STATE OF CONNECTICUT
CONNECTICUT SITING COUNCIL

IN RE: :
: :
APPLICATION OF CELLCO PARTNERSHIP : DOCKET NO. 350
d/b/a VERIZON WIRELESS FOR A : :
CERTIFICATE OF ENVIRONMENTAL : :
COMPATIBILITY AND PUBLIC NEED FOR : :
THE CONSTRUCTION, MAINTENANCE : :
AND OPERATION OF A WIRELESS : :
TELECOMMUNICATIONS FACILITY IN THE : :
TOWN OF WOODSTOCK, CONNECTICUT : JANUARY 8, 2008

RESPONSES OF CELLCO PARTNERSHIP D/B/A VERIZON WIRELESS TO
CONNECTICUT SITING COUNCIL PRE-HEARING INTERROGATORIES

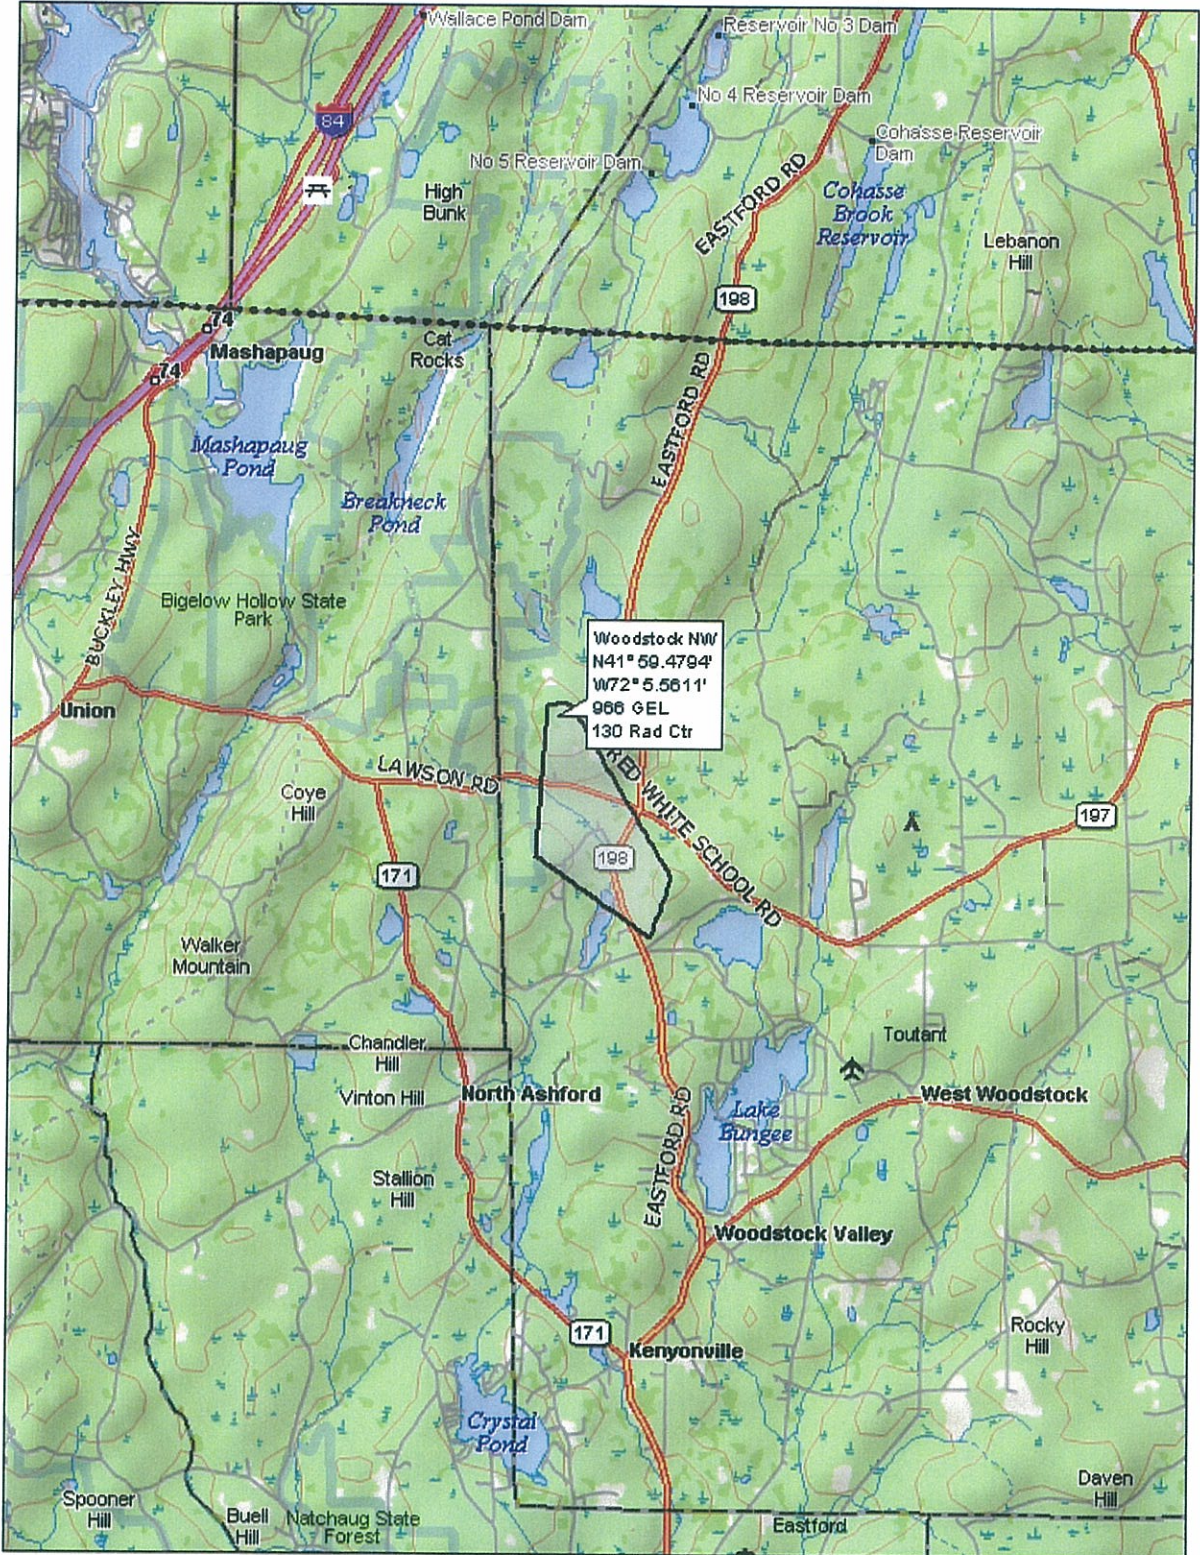
Clarify the discrepancy of the location of the proposed access drive on a map behind Tab 12 and Tab 1, Drawing S-1.

At the time of the wetland site inspection in June of 2007, final plans for the access road including a more precise routing of the access road, had not been developed. The plan included as a part of the wetlands report behind Attachment 12 and also as a part of the lease exhibit behind Attachment 14 of the Application depict a conceptual access road location. The final access road design as depicted in Drawing S-1 behind Attachment 1 of the Application illustrates an engineered road design taking into consideration the location of existing logging roads that runs through the subject parcel, site topography, and wetland impacts.

Docket No. 350
 Response to Interrogatory Question 7
 Existing Verizon Wireless Cellular Coverage With
 Proposed Facility At 127 Feet AGL

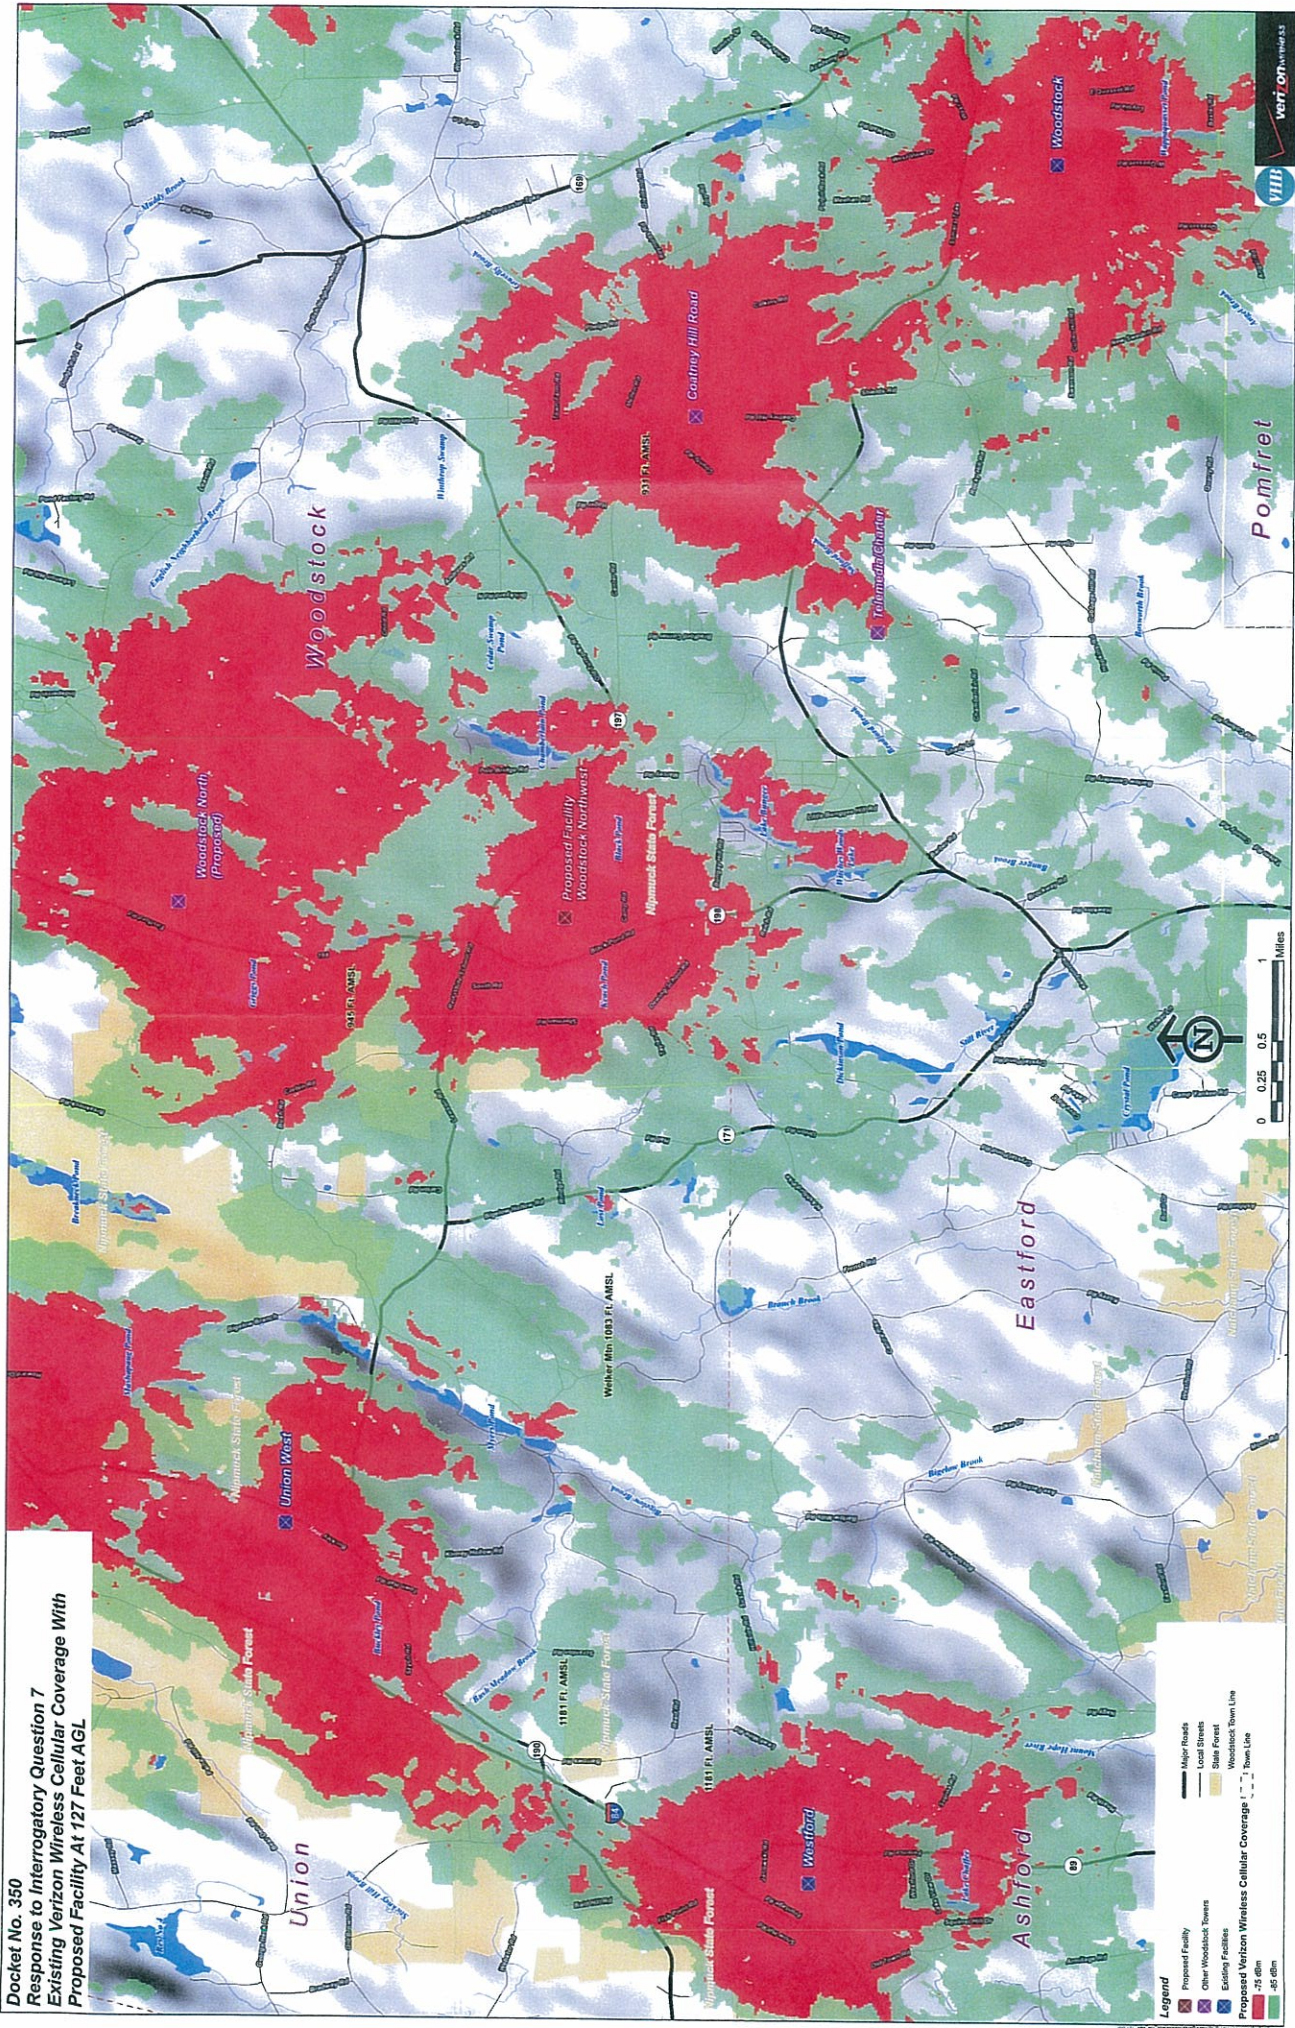
On Tab 7 of Verizon Wireless' Application for a Certificate of Environmental Compatibility and Public Need (Application), coverage plots are provided to show the existing coverage and the coverage with the proposed antennas centered at 137'. Provide cellular and PCS coverage plots (using the same scale provided) assuming the antennas are located at 127' and 117', respectively.

Coverage plots requested are included behind Tab 2. Coverage at the various heights is quantified in the table below.

<u>Proposed Coverage at 127'</u>	<u>Cellular</u>	<u>PCS</u>
Route 198	2.74 miles	2.32 miles
Route 197	4.26 miles	2.56 miles
Route 171	2.17 miles	0 miles
Overall	8.9 square miles	2.62 square miles
